МЕМО

Subject: Review of Water Right Application G-17937

PUBLIC INTEREST REVIEW FOR GROUNDWATER APPLICATIONS

| TO: | | Water | Rights S | ection | | Date March 16, 2015 | | | | | | | | |
|---------------------------------|--|-----------------------------|-------------------------------------|---|--|--|-----------------------------|---|----------------------------|--------------------|--------------------------|------------------------|------------------|--|
| SUBJE | CT: | Applic | cation G- | 17937 | | Revi Su | ewer's Nam persedes | review of | | | Date of Re | view(s) | · · · | |

D. WELL CONSTRUCTION, OAR 690-200

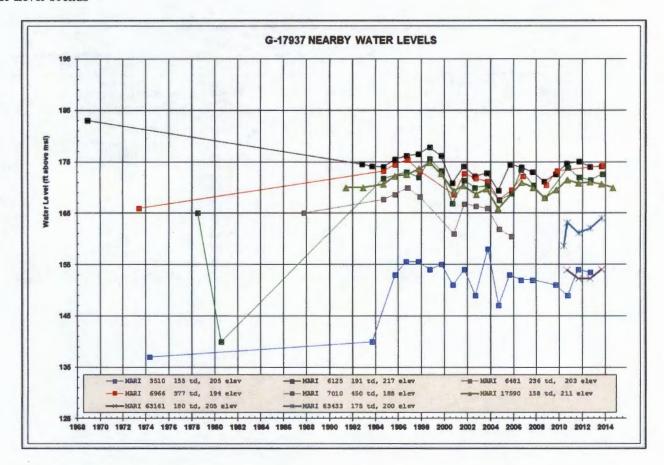
| D1. | Well #:1 Logid:MARI 6106 |
| D2. | THE WELL does not appear to meet current well construction standards based upon: a. review of the well log; b. field inspection by report of CWRE d. other: (specify) |
| D3. | THE WELL construction deficiency or other comment is described as follows: |

| D1. | Well #:1 Logid:MARI 6106 |
|-----|--|
| D4. | Route to the Well Construction and Compliance Section for a review of existing well construction. |

Stream Depletion Model Results

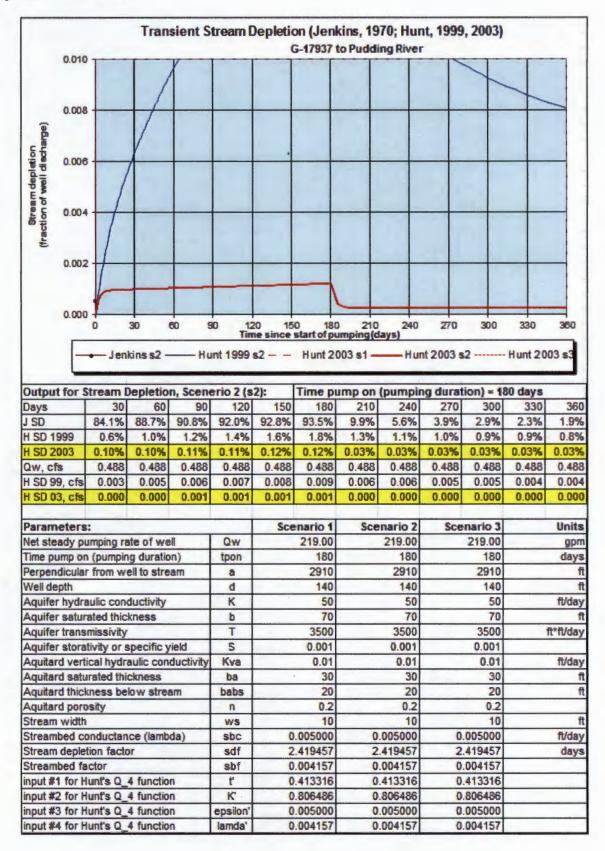
Comments: The Pudding River stream depletion at 30 days was estimated using the Hunt 2003 model. The presence of low permeability Willamette Silt between the aquifer and the beds of streams results in an inefficient connection between the aquifer and the stream, therefore the stream depletion at 30 days is much less than 25%. However, stream depletion will increase over time until all of the pumped water is balanced by reduced stream flow.
